No. Desk-17/Nodal/Dhule/ID-12908/2421/2022-23

**Sub:-** Diversion of 31.49 ha. Reserved Forest land in favour of Executive Engineer, Minor irrigation Division, Jalgaon for construction of Handya Kundaya Storage Tank near Village-Deohari, Taluka-Chopda, District-Jalgaon in the State of Maharashtra regarding

Compliance chart on the quarries raised by the APCCF & Nodal Officer, Nagpur vide letter no Desk-17/NC/II/ID.12908/226/20-21 Dated 03/06/2021 on Diversion of forestland proposal of Handyakundya Minor Irrigation Project Tal. Chopda Dist. Jalgaon. (Forestland 31.49 Ha)

## PHOTOPLATE I

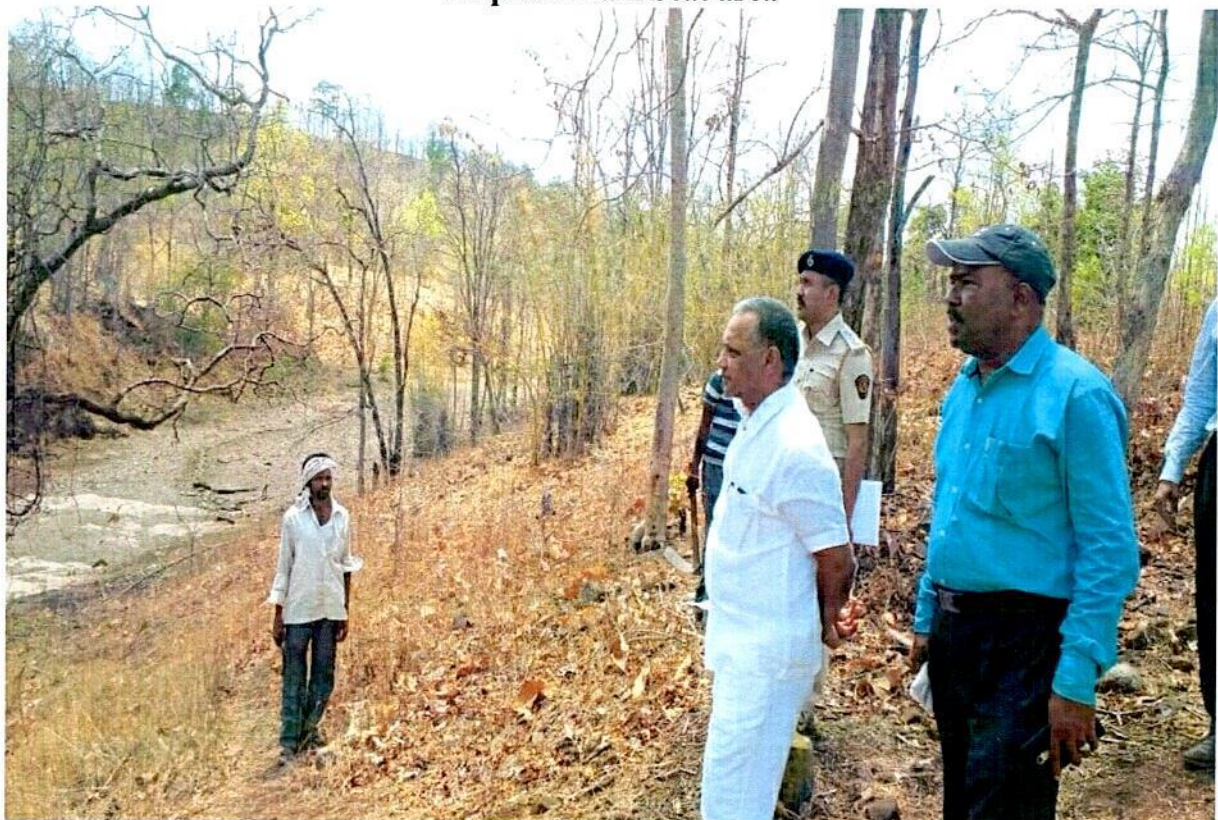
Trees proposed for felling under dam sheet and approach & tail channel appears on the higher side. Basically 80% of the trees proposed for diversion are in 3.00 ha (Dam Seat) & 2.00 (Tail Channel) ha. these trees falls under girth size of 0 to 45 cm. These trees are shoots developed on one stalk and trees above 46 to 135 cm is less. Enclosed site photograph of site inspection by Mr. P. T. Morankar Dy CF, Yawal Forest Division, Jalgaon
